ANNEX 1: Proposed scheme

Project title					
WOOTTON ROAD, ABINGDON CYCLE INFRASTRUCTURE					
Drawing title					
Consultation Drawing					
Drawing Status					
Consultation					
Drawn @ MS	Drawn by	Checked by	MW	Approved by	MW
NTS	Date drawn 16.05.13	Date checked 21/06/13	Date approved 21/06/13		
Calculation Project No. & File Path

ANNEX 2: Consultation Summary with Officer Response

Drawing No.	S-000637/CON/000/001	Revision	0

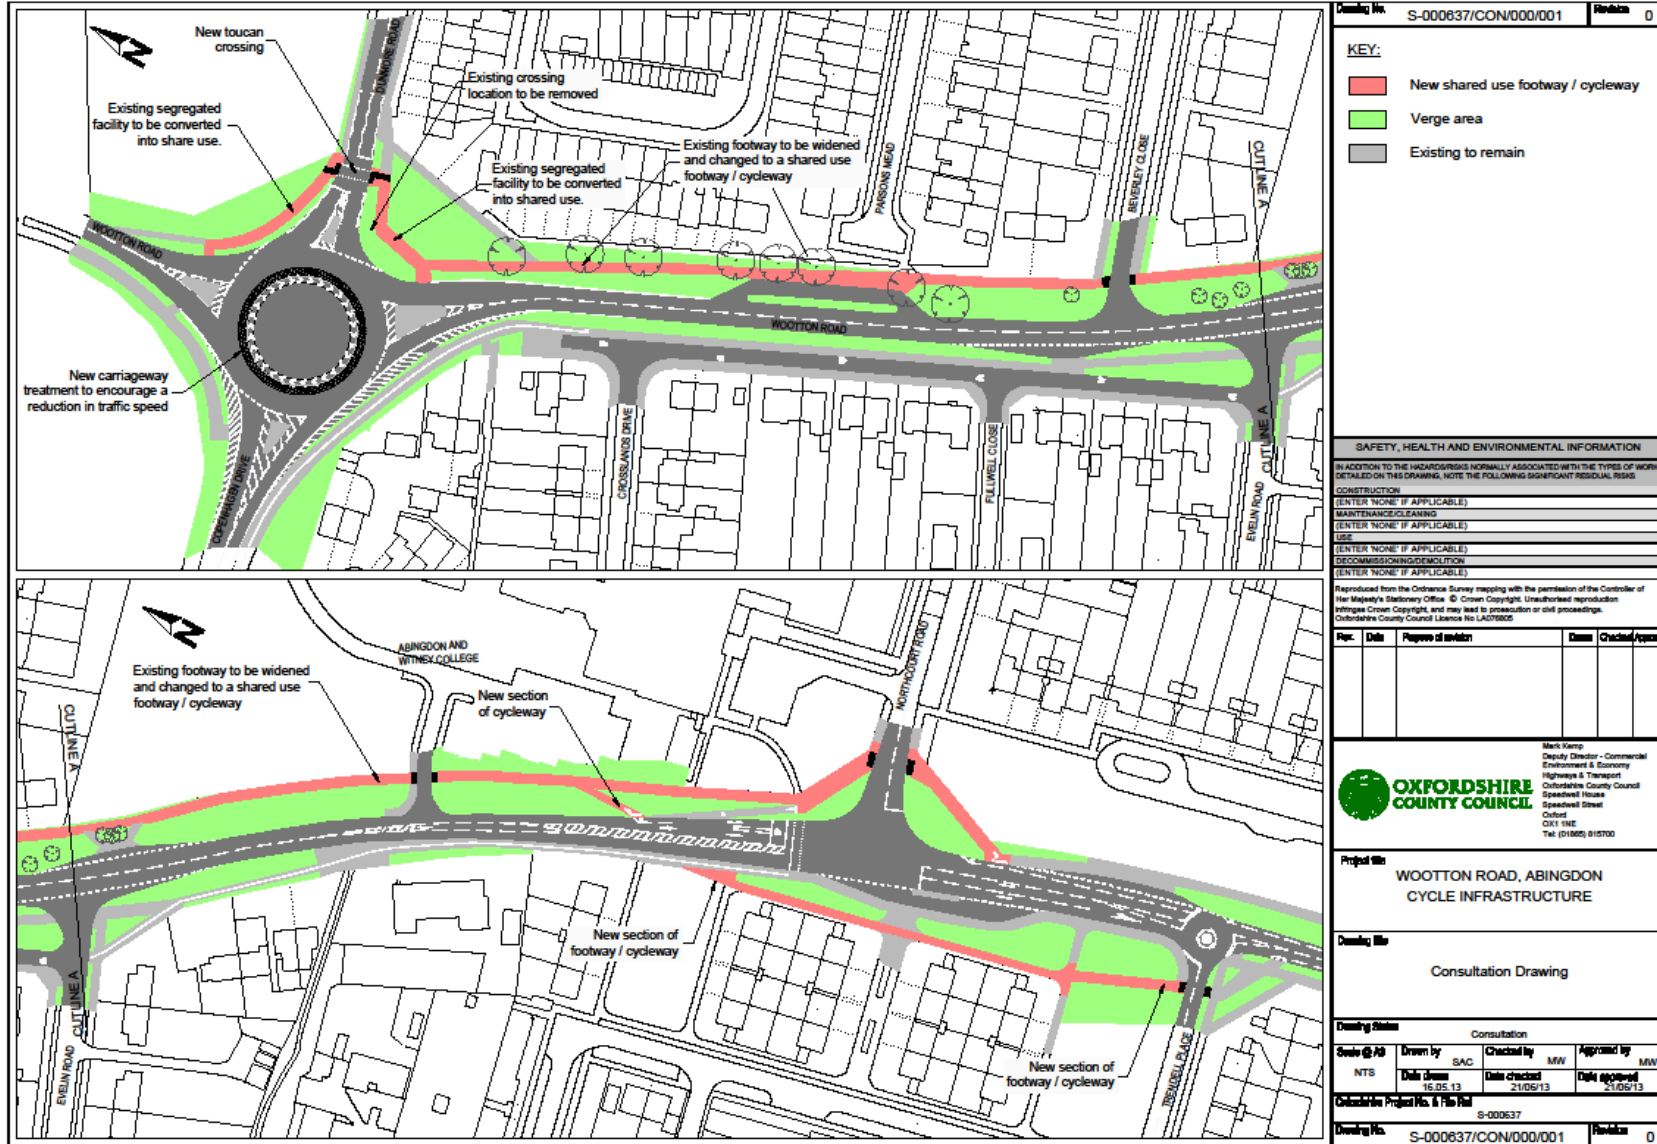
Consultation comment	Officer response
Proposed toucan crossing too close to roundabout	Crossing is within regulation distance from the roundabout. It is necessary to be close to the roundabout to prevent an unreasonably long detour for cyclists.
Proposed toucan crossing should be on Wootton Road not Dunmore Road	The toucan crossing is located on the Dunmore Road arm of the roundabout as this is where the majority of accidents have occurred.
Concern over shared use paths and pedestrian safety/conflict	While there may be a perceived risk of cyclists colliding with pedestrians on shared use paths, this is extremely rare. Shared use paths provide a safe means to travel for both pedestrians and cyclists. Faster moving cyclists are more likely to stay on the carriageway.
Concern over shared use paths and loss of priority at side roads for cyclists	This is acknowledged and the final scheme design will address this where possible.

Scheme is a waste of money	The majority of the funding for the scheme is from the DfT Cycle Safety fund set up to address an identified cycle safety issue. The funding has been awarded for this scheme and cannot be reallocated to any other scheme.
Cyclists will ignore paths and stay on road	Cycle paths in this scheme are provided to give less confident cyclists an alternative to riding on the carriageway. Cyclists are not obliged to use the paths and it is intended that more confident cyclists will remain on the carriageway.
Noise from toucan crossing	It is not thought that sound from the crossing will be a problem. However, if concerns persist after installation amendments to the crossing sound can be made.
Reduce speed limits	It is intended the scheme will address the safety issue at the roundabout without requiring a reduction in road speed limits.
Significant scheme alterations/alternate scheme proposals, such as signalling the roundabout	Some significant scheme alterations and alternate schemes were proposed. While some of these may have merit, the funding has been made available for the scheme as proposed. While some changes to the scheme may be possible, more significant alterations or alternate schemes are out of scope at this time.
